Device	XMC1100
Marking/Step	EES-AB, ES-AB, AB
Package	PG-TSSOP-16/38, PG-VQFN-24/40

Overview

This “Errata Sheet” describes product deviations with respect to the user documentation listed below.

Figure 1 Clock Selection Diagram for CCU4/CCU8

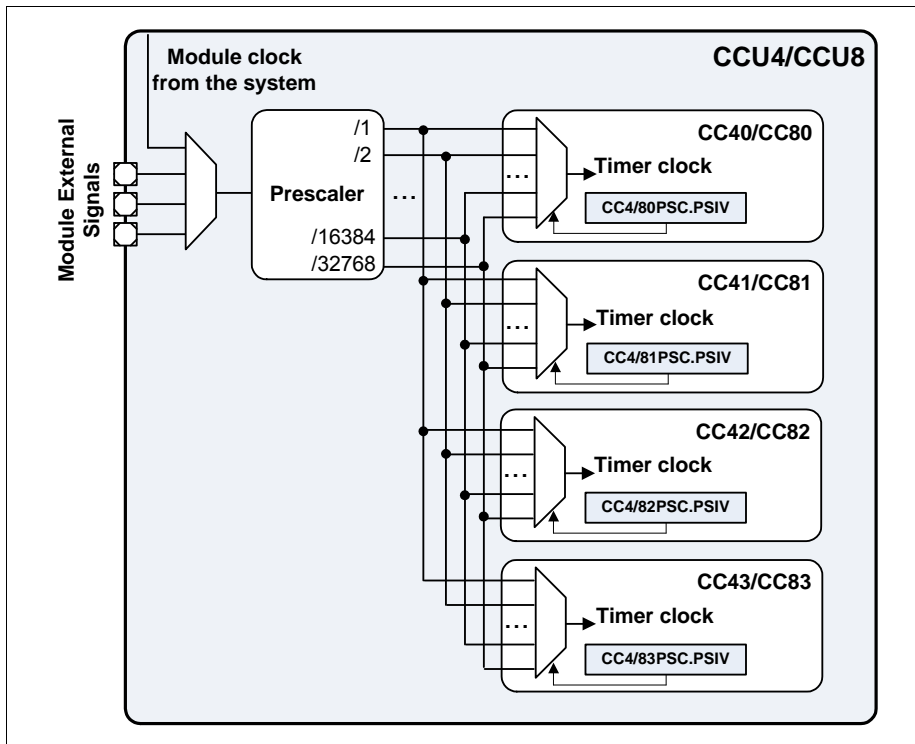
Each CCU4/CCU8 module offers the possibility of selecting an external signal to be used as the master clock for every timer inside the module Figure 1. External signal in this context is understood as a signal connected to other module/IP or connected to the device ports.

Currently is only possible to use an external signal as Timer Clock when a division ratio of 2 or higher is selected. When no division is selected (divided by 1), the external signal cannot be used.

The user must program the PSIV field of each Timer Slice with a value different from 0000_B - minimum division value is /2.

This is only applicable if the Module Clock provided by the system (the normal default configuration and use case scenario) is not being used. In the case that the normal clock configured and programmed at system level is being used, there is not any type of constraints.

Workaround

None.
